# REQUEST FOR INFORMATION (RFI)

RFI No.: ABF-RFI-003170R01 Submitted By: OSullivan, Bill Pages: 1  
 RFI Date: 11-February-2013 Contact Name: Osullivan, Bill Phone No. 510-808-4602  
 Pages Attached: 0

<b>Subject:</b> Light Pole Anchor Bolts: Scope of Work	
<b>References:</b>	
<b>Sub/Sup:</b> ABF	<b>Sub RFI #:</b>
<b>Response Required by:</b> 18-February-2013	<b>Response affects critical path activity?</b>

RFI No.: 3170R1 (Rev 7-19-13)

**DETAIL C**

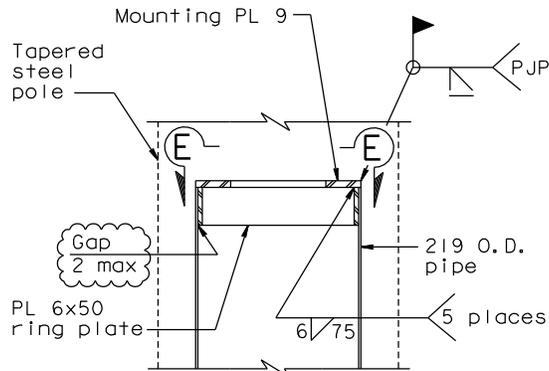
- 1) Please confirm that it is acceptable to remove the seal weld at the bottom of the "Slip Joint Detail" on Sheet 214R2 given that it is not accessible.

- 2) Please confirm that it is acceptable to increase the "0 gap" in Detail C on Sheet 901R5 to "2 max gap".

- 3) Please confirm that it is acceptable to use a PL12 in lieu of a PL9 in Detail C on Sheet 901R5, at the Contractor's suggestion (and at his option), to provide more embedment length for the A325 bolts..

Per WDC discussion on 7/19/13, connection of the belvedere light pole to the light pole base has been modified to facilitate light pole installation. Please find attached sketches SK-3170R1-1 and SK-3170R1-2 for details of the belvedere light pole base. The mounting plate / ring plate assembly will be State-furnished.

As we discussed, Jal is OK with using the 3/8" thick mounting plate as shown in Detail C on Sheet 901R5.

The light pole bases are being fabricated with PL9 (3/8" plate) as shown in Detail C on Sheet 901R5, not with a 1/2" plate as requested by the Contractor (see below). I assume this is acceptable because that is what is shown on the plans, and there are no concerns about embedment length. Please confirm.

**SECTION E-E**

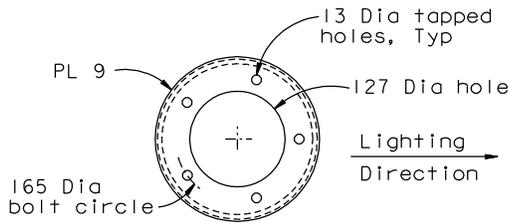
In reference to the response to RFI-3170 R0, Item 8; ABFJV requests the Department to provide a revision to Plan Sheet 901R4 that incorporates the details shown on the Valmont shop drawings.
